## **Remarks**

### ***Drawings***

# Annotated Marked-up Drawings

Fig. 11  
(Prior Art)

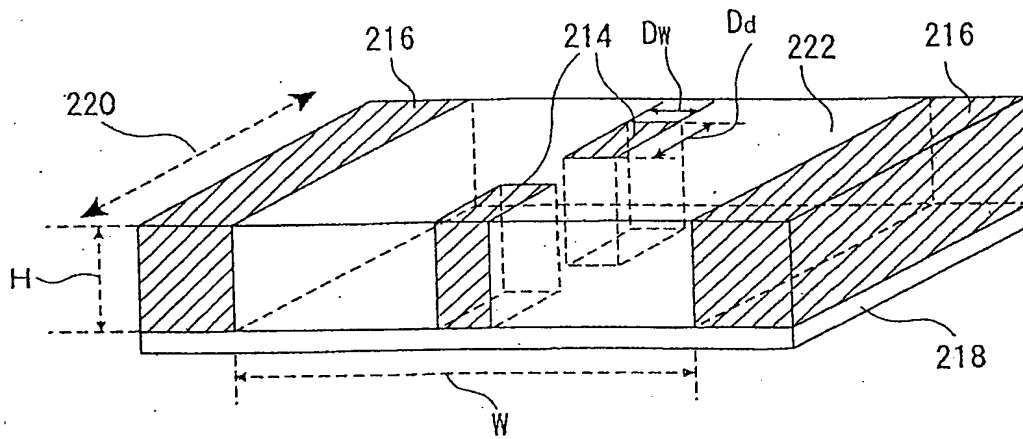
The Office Action objected to Figs. 10 and 11 for failing to include a legend indicating that the figures are "Prior Art". As shown in the attached replacements sheets for Figs 10 and 11, these figures now include the legend - - (Prior Art) - - . Marked-up copies of Figs 10 and 11 showing the changes in red are also attached.
